EQUIPMENT: RT-406F

BULLETIN NUMBER: WSB RT-406F-4 Revision A

This Service Bulletin explains how modify the RT-406F Receiver Board for improved performance.

Figure 1

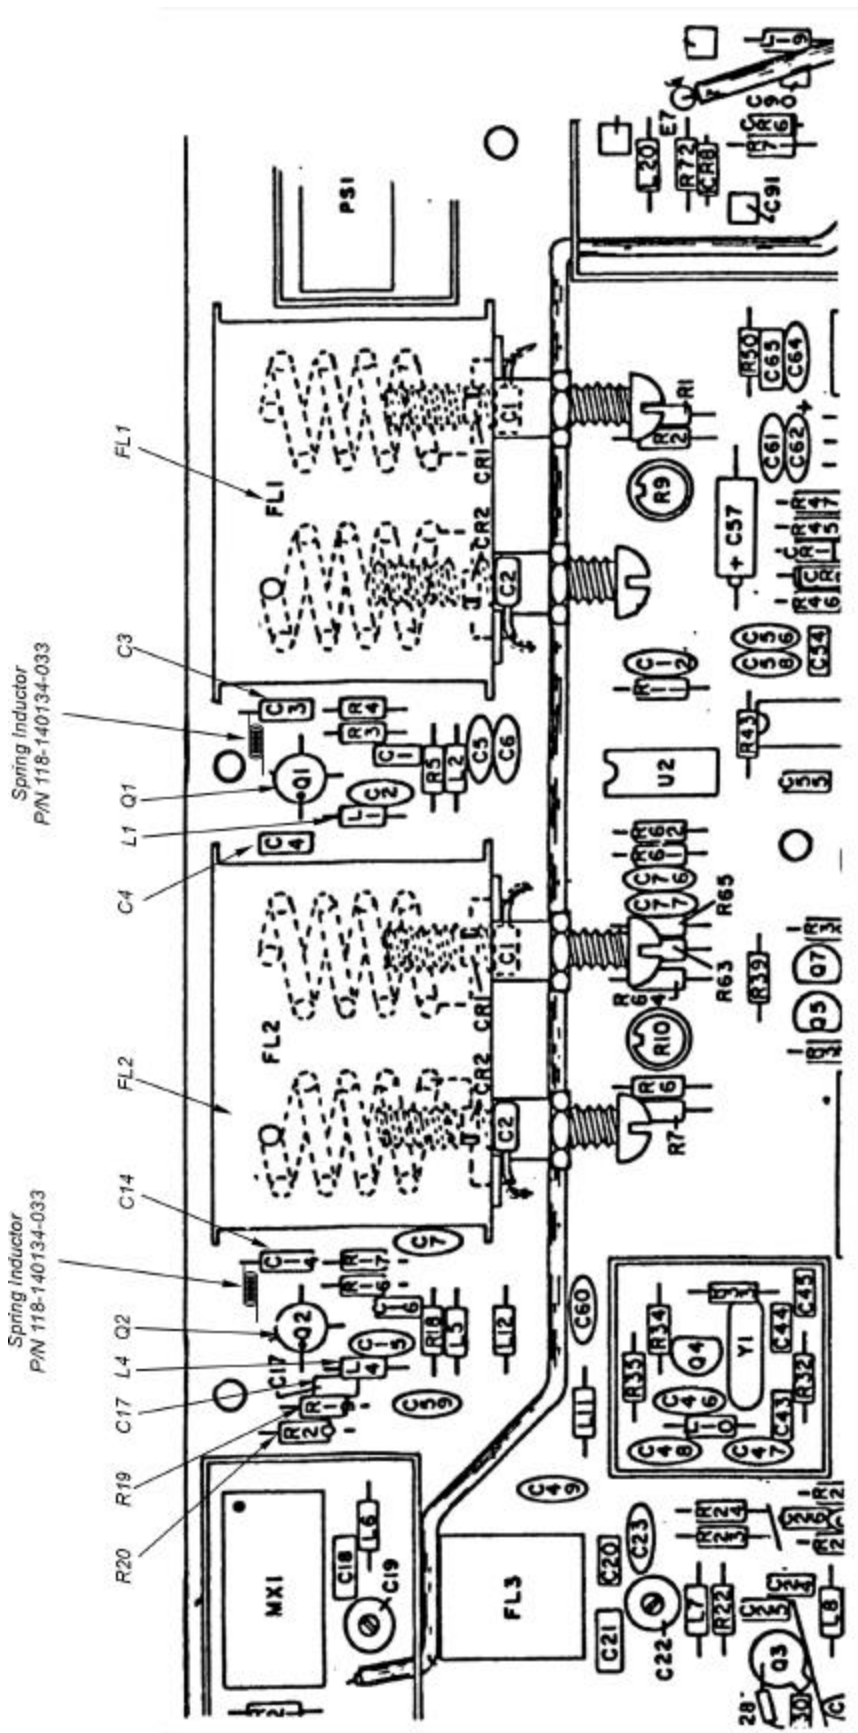
1. Replace Resonators FL1 and FL2 P/N 300-2251-001 Rev. E with Resonators P/N 300-2251-002 Rev G (refer to Figure 1).
2. Solder 22 AWG Bus Wire P/N 16017-22 from end of coaxial to ground plane using pads if available (refer to Figure 2). Remove conformal coating and solder resist as required to solder to ground plane.
3. Remove Resistors R19 and R20 (refer to Figure 1).

4. Replace Transistors Q1 and Q2 with P/N 106-040856-01 (refer to Figure 1). Orient Q1 and Q2 as shown in Figure 3. Remove conformal coating and solder resist as required to solder additional pin to ground plane.

5. Replace Capacitors C4 and C17 with P/N 209-1100-106 (refer to Figure 1).
6. Replace Chokes L1 and L4 with Resistors P/N 230-040008-101 (refer to Figure 1). Solder Spring Inductors P/N 118-140134-033 to legs of resistors, positioned approximately as shown (refer to Figure 4).

7. Solder one lead of Spring Inductor P/N 118-140134-033 to Capacitor C14 and the other lead to ground (refer to Figure 1). Remove conformal coating and solder resist as required to solder to ground

8. Solder one lead of Spring Inductor P/N 118-140134-033 to Capacitor C3 and the other lead to ground (refer to Figure 1). Remove conformal coating and solder resist as required to solder to ground

Figure 5

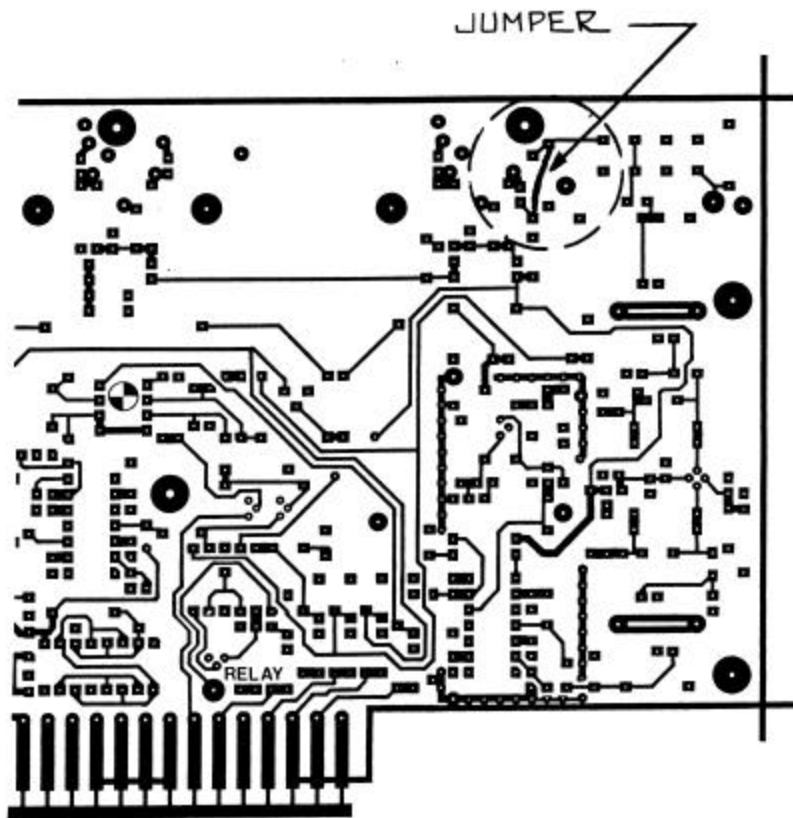
8. Add Jumper Wire P/N 16017-22 on solder side of board as shown (refer to Figure 5).
